# Memo

Re: 8. ACTION RE: PETITION FROM DAVID COWLES – REQUESTING PRELIMINARY PLANNED DEVELOPMENT DISTRICT APPROVAL FOR A MID-RISE RESIDENTIAL CONDOMINIUM BUILDING ON PARCEL AL-79, LOCATED AT 2222 RIVERSIDE DRIVE (current Mariner Motel property)

# Preliminary PDD Review – Staff Comments

**Site:** 2222 Riverside Drive (Parcel AL-79)

# SITE PLAN

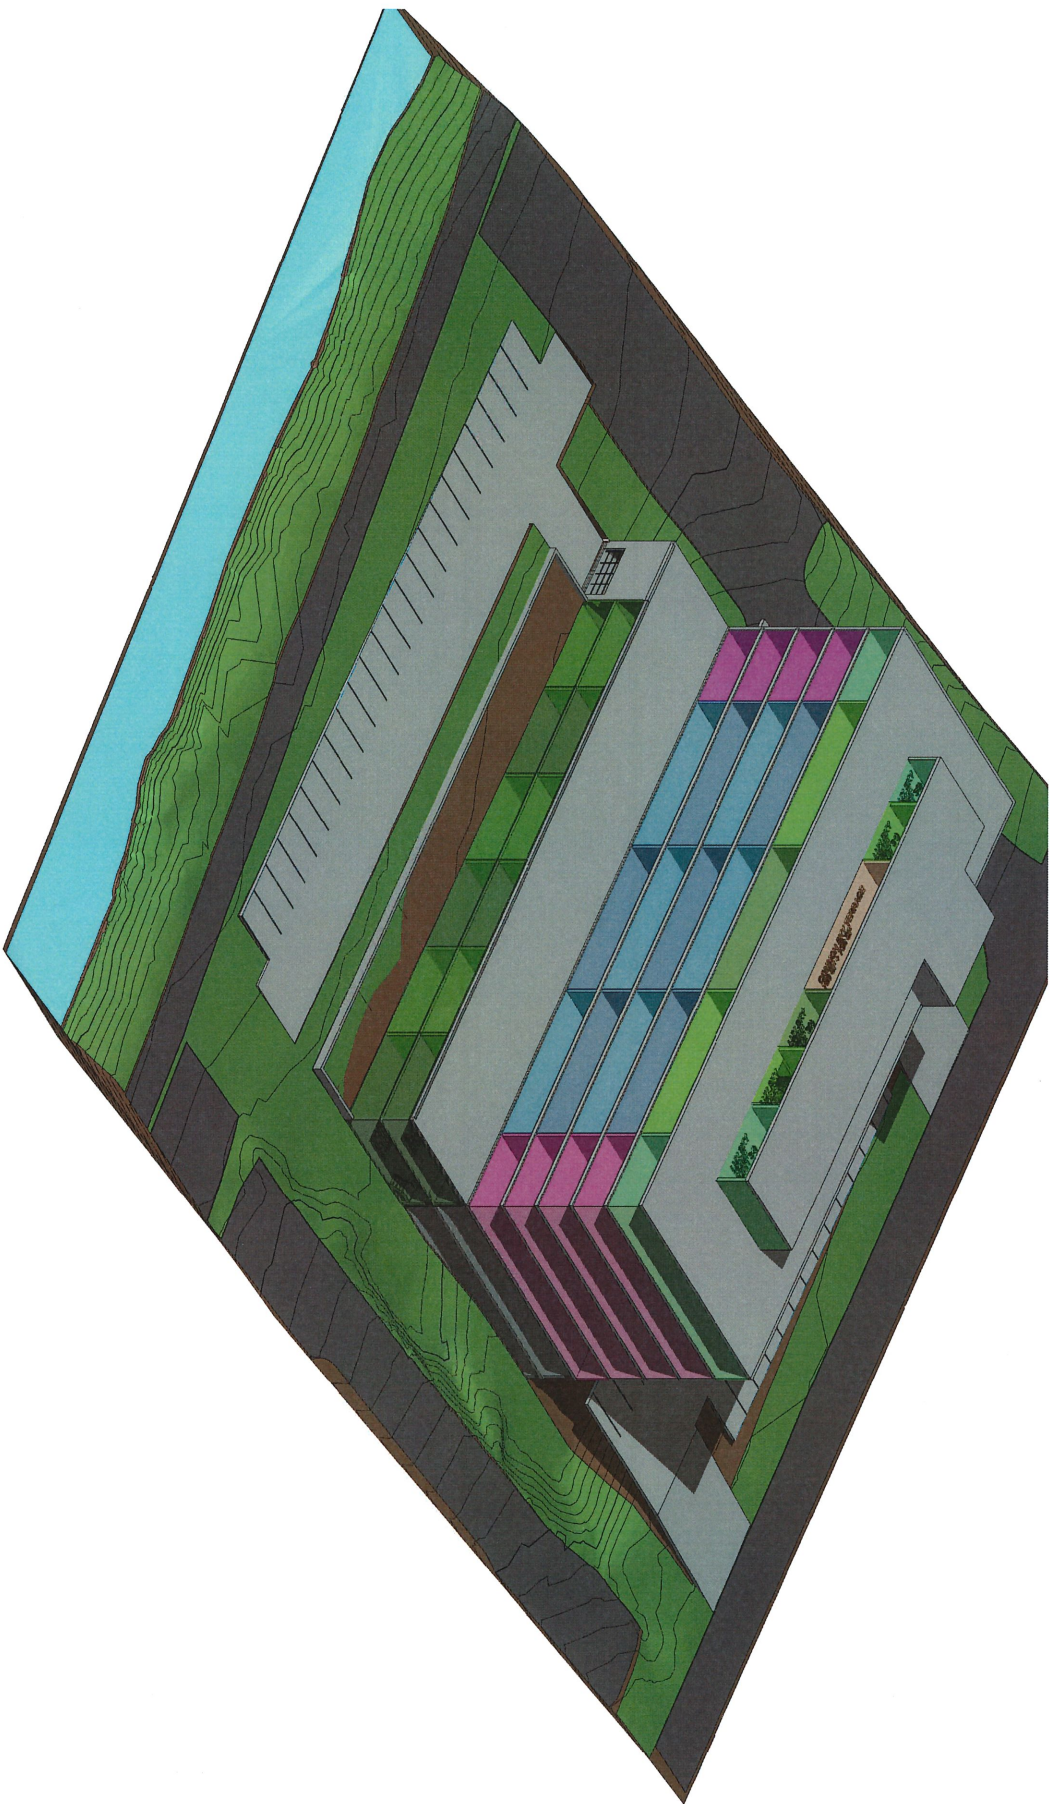
- The building setbacks are consistent with the setbacks required in commercial zoning.
  - Shared driveways should continue to be used.
  - Green space does not appear to be adequate at this time, but can be a concession by the village through the PDD process.

- Parks, Recreation, Forestry Department review:
  - Is there room on the south side of the development for a public easement for a trail connection?
- Building Inspection review:

Any Public access to the Fox River Trail will have to be debated with neighbors, and the Village, etc., as there is no public access or parking right now, but is used illegally by many, and liability concerns abound.

# SECTION AND BUILDING DATA

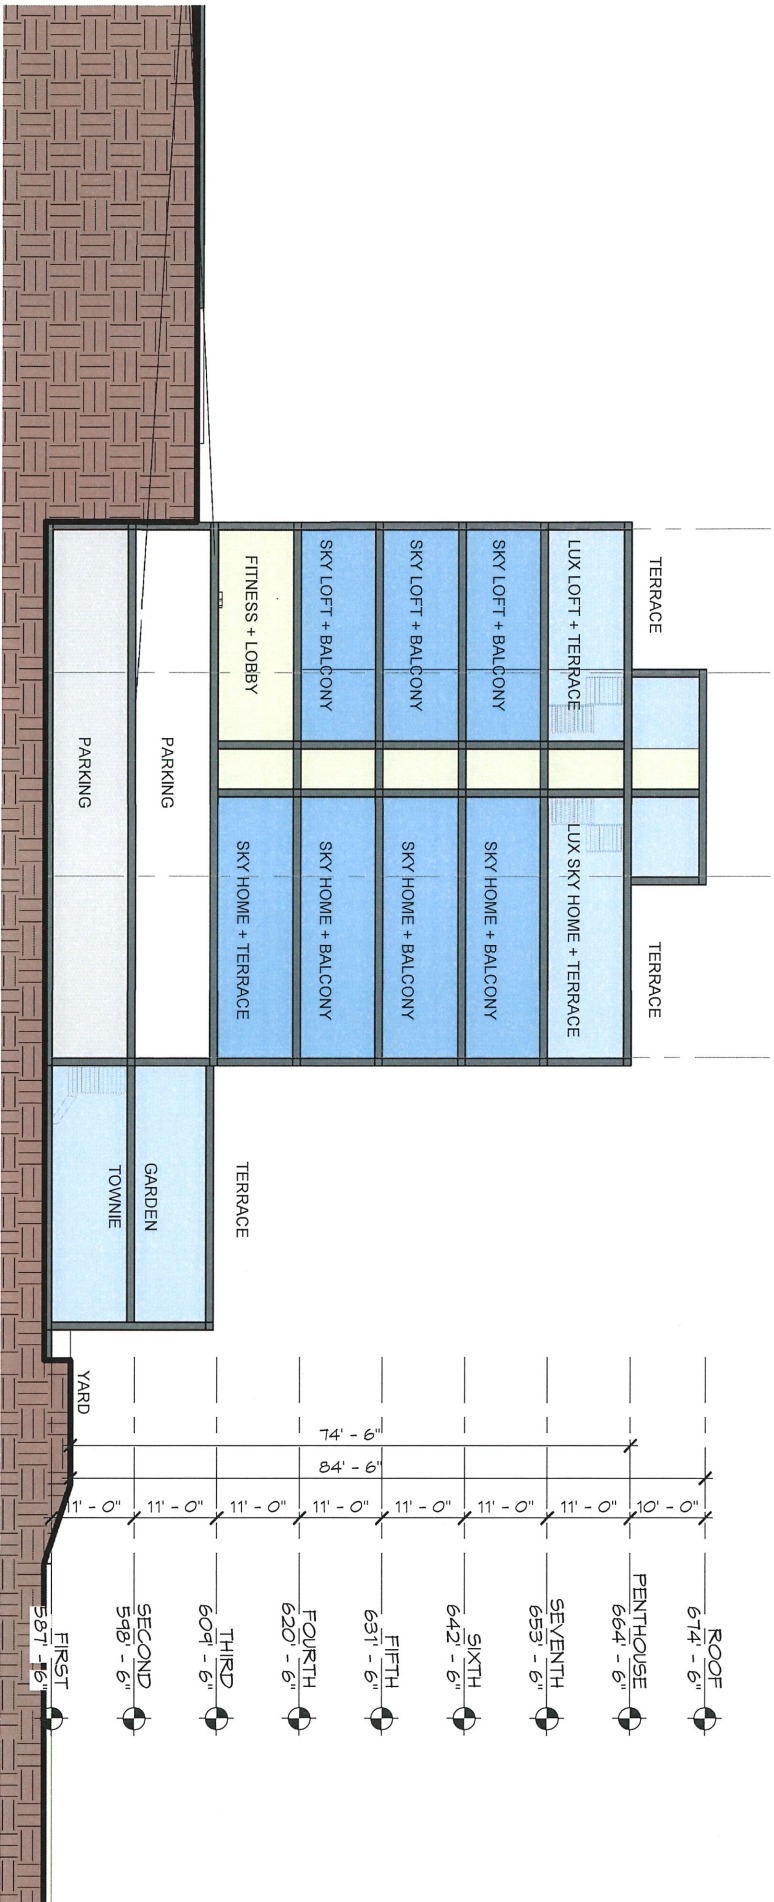
- The proposed building height is six stories from Riverside Drive. Zoning code allows for four stories from fronting road for “commercial” zoned parcels.

- Fire Department review:
  - A challenge will be with getting the proper grade to the bottom parking lot (keeping it under 10% grade).
  - The building is six inches under the high rise requirements.
